STMO Bn, LLC (Starfire)
Responses to Siting Board Staff's First Request for Information
Case No. 2024-00255

**Starfire Solar Project
Knott, Perry, and Breathitt Counties,
Kentucky**

**Item 10: Preliminary Construction
Routes Map**

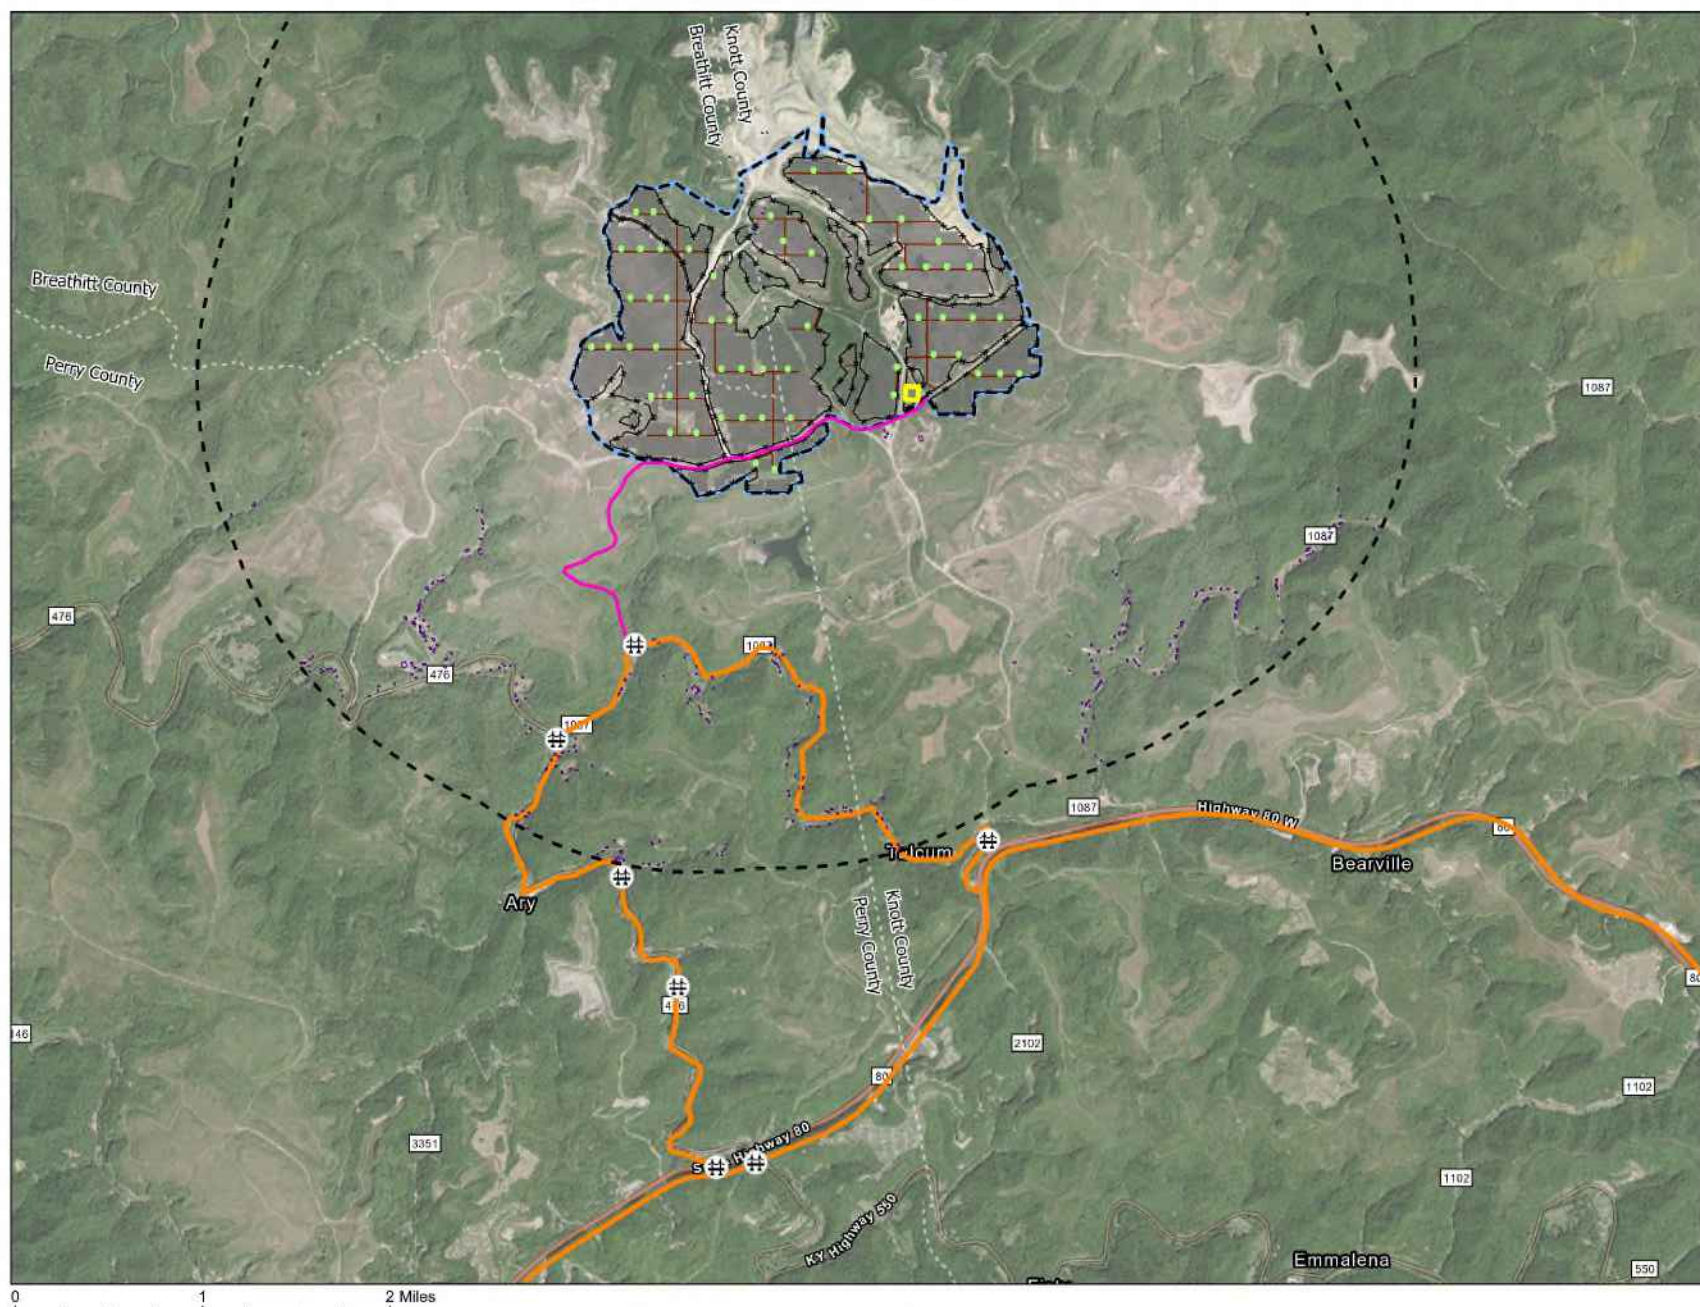
Provide a one-page directional map showing highlighted anticipated delivery routes for the project.

Include on the map: access roads, access points, existing roads, bridges, electric generation components, and all structures within two miles of the project.

See attached.

Item 13: Proposed Vegetative
Clearing

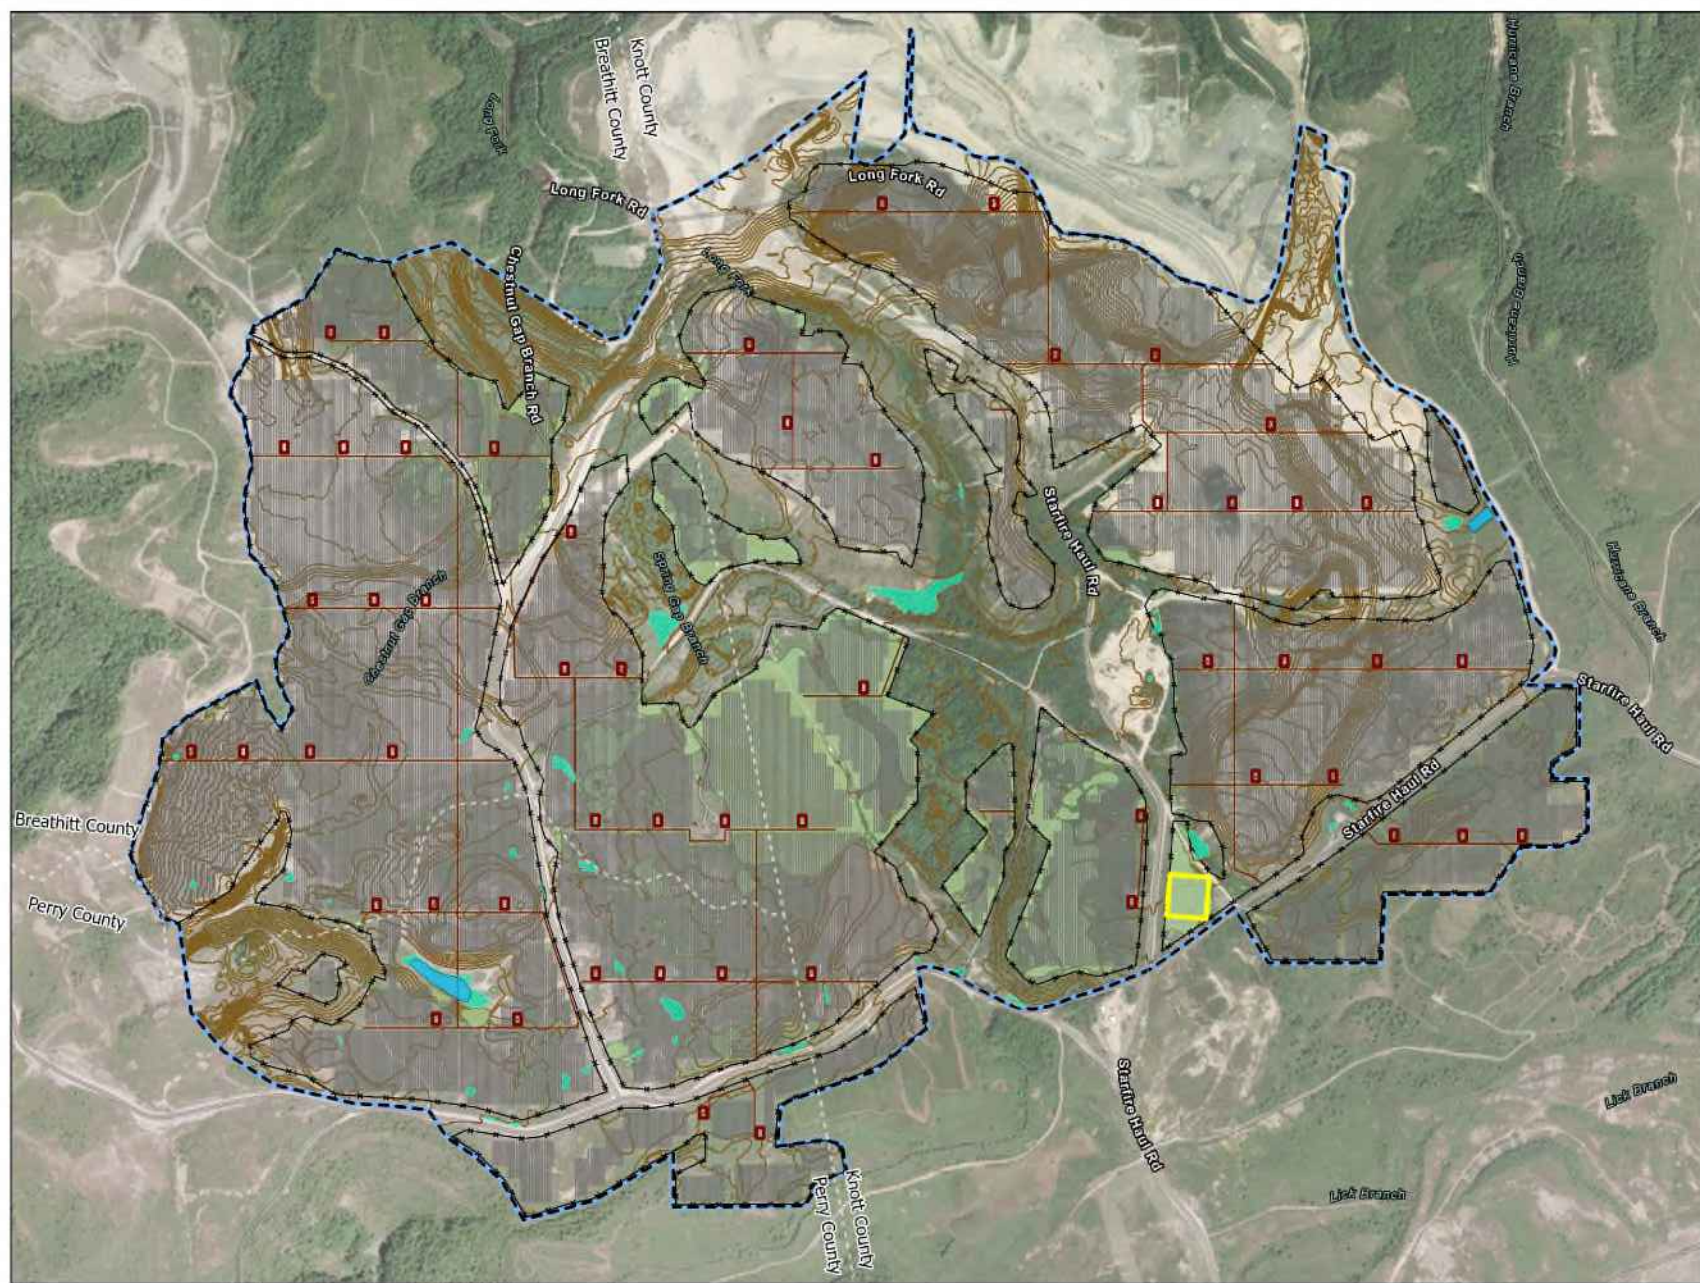
Provide a map showing all planned areas of vegetative clearing. Include on the map satellite imagery, wetland features, and elevation contours.

See attached.

Item 17a: Oil & Gas Wells

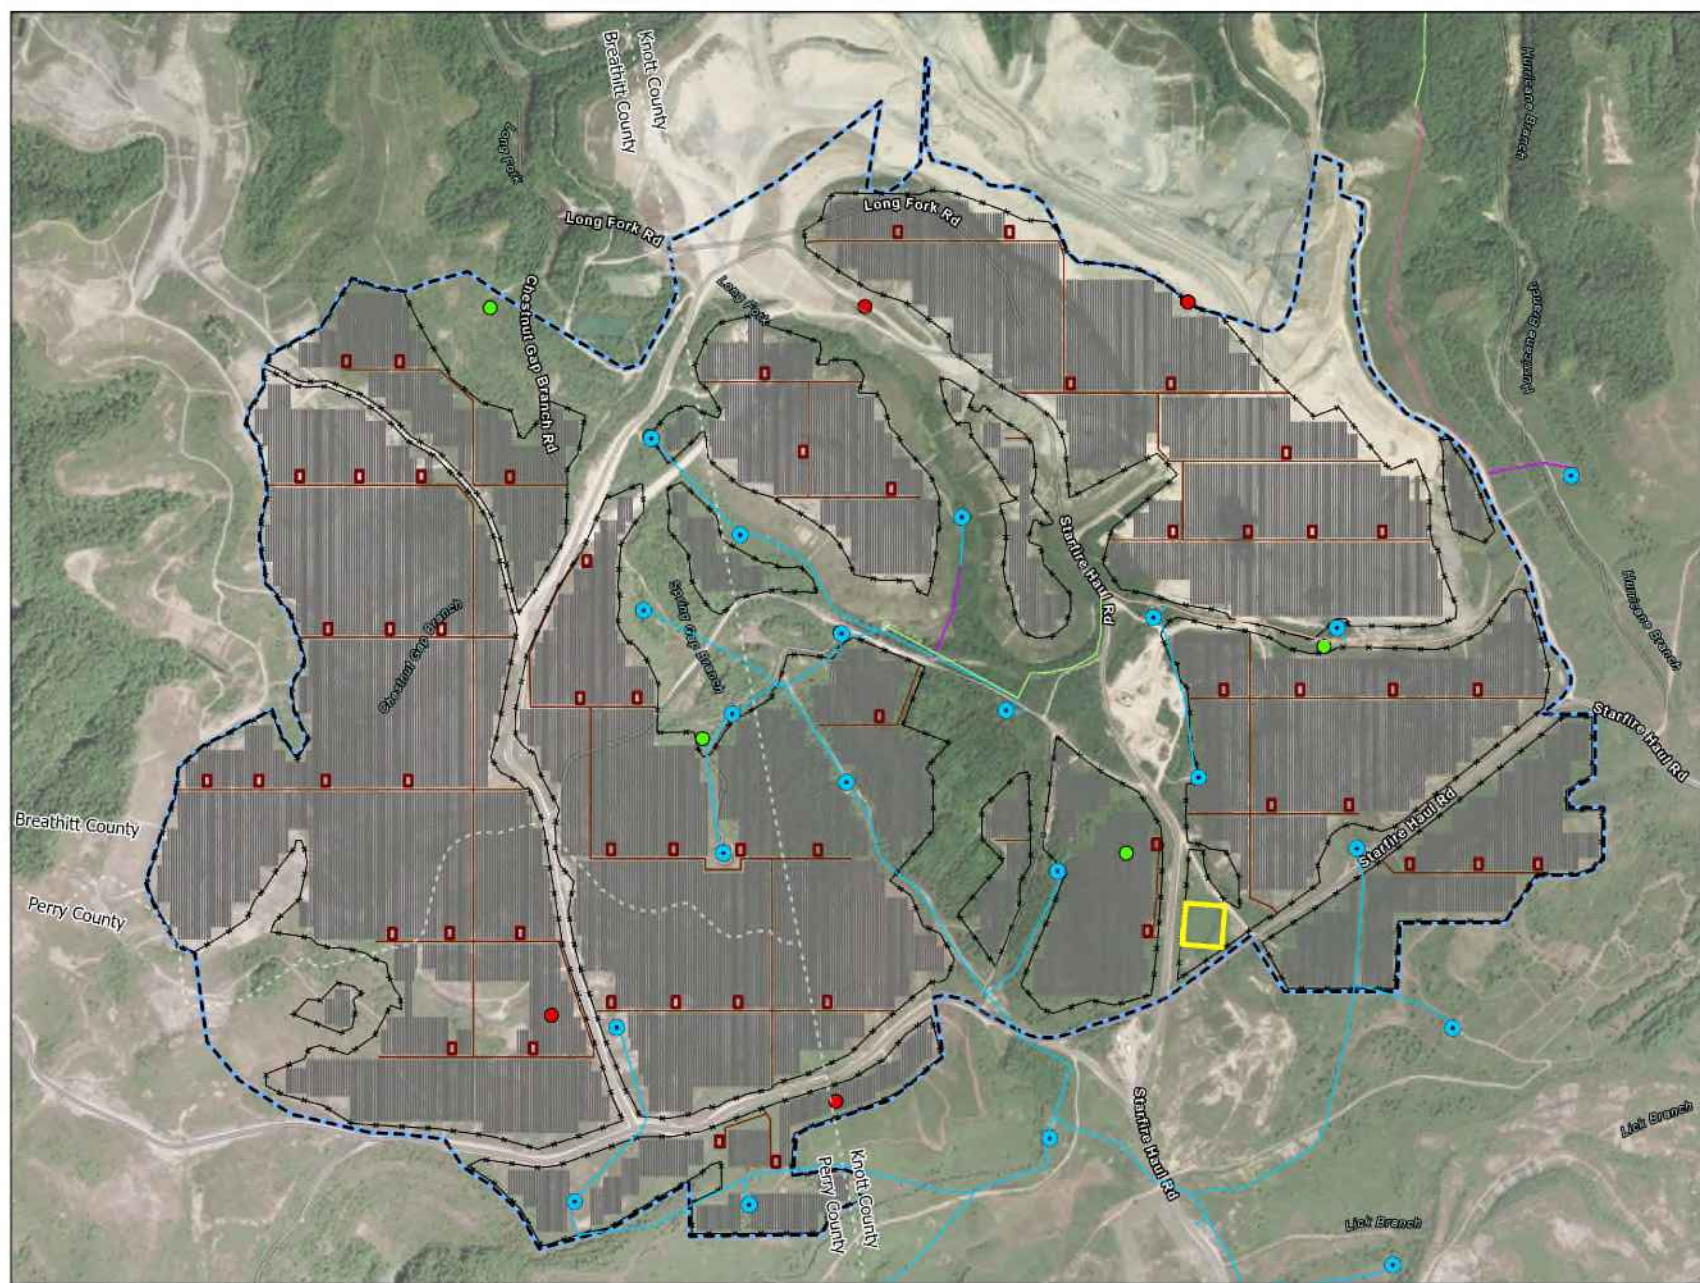
- a. File a map identifying all active and inactive oil or gas wells on the proposed site. Also include any gas-gathering pipelines associated with the wells.
- b. Determine and explain whether any of these wells are currently permitted and active. If active, identify the wells as such on the map provided in response to Item 17(a).
- c. Explain whether the existence of oil and gas wells and pipelines will require adjustments to the proposed location of solar panels.

- a. See attached.
- b. See map provided in response to 17(a) for any currently permitted and active wells based on the KGS website.
- c. There is at least one well that may require adjustments to the proposed location of panels. It is anticipated that some wells may be inactive by the time construction commences. Project representatives plan to communicate with well owners regarding these well locations within the next several months.

Cemeteries

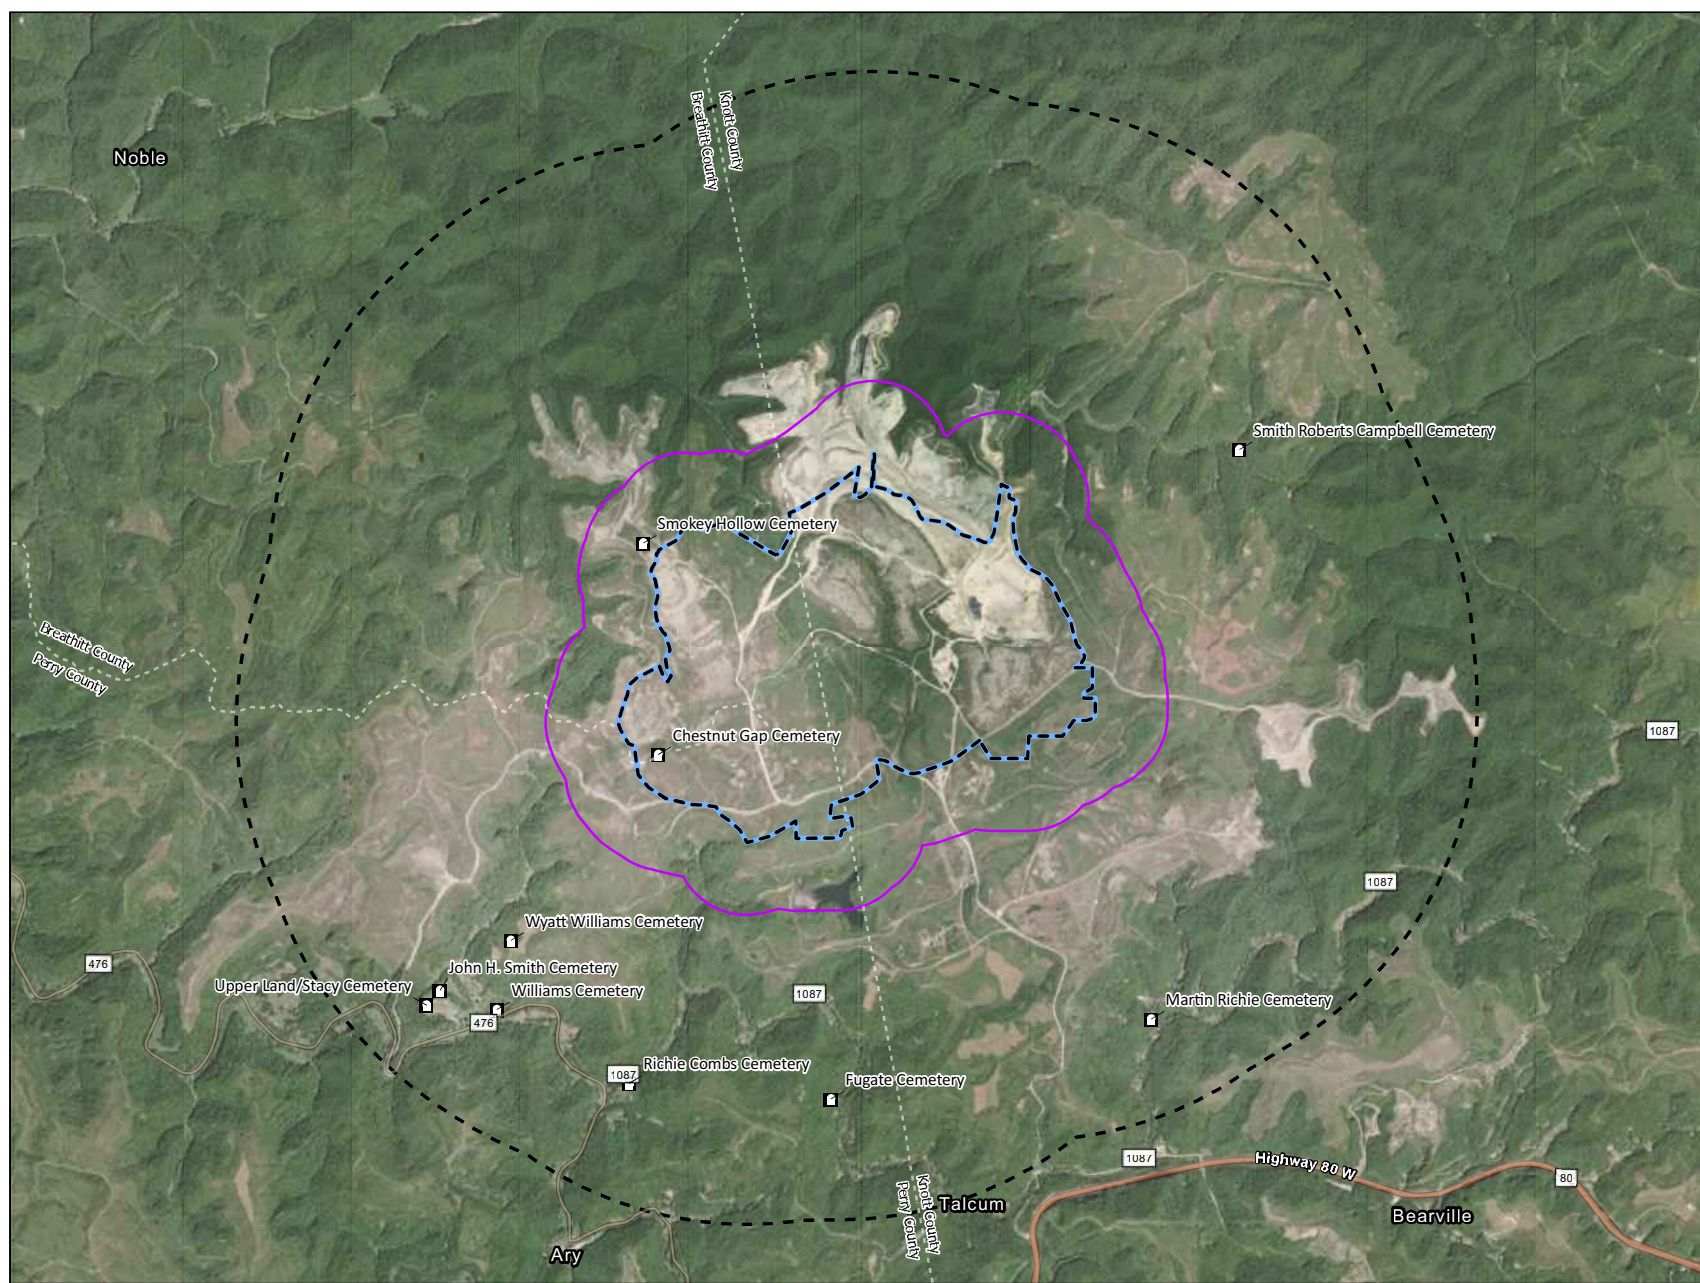
Identify all cemeteries located within a two-mile radius of the project on a map and identify if the project will restrict access to them in any way.

See attached. Nine cemeteries have been identified within two miles of the Project. Of these, two cemeteries may be subject to restricted access: Chestnut Gap Cemetery, located within the Project boundary; and Smokey Hollow Cemetery, which is located outside the boundary but within 2,000 feet of the Project site. The remaining seven cemeteries will not be subject to restricted access: Williams Cemetery, Smith Robers Campbell Cemetery, Upper Land/Stacy Cemetery, Wyatt Williams Cemetery, Richie Combs Cemetery, Martin Richie Cemetery, and John H. Smith Cemetery.
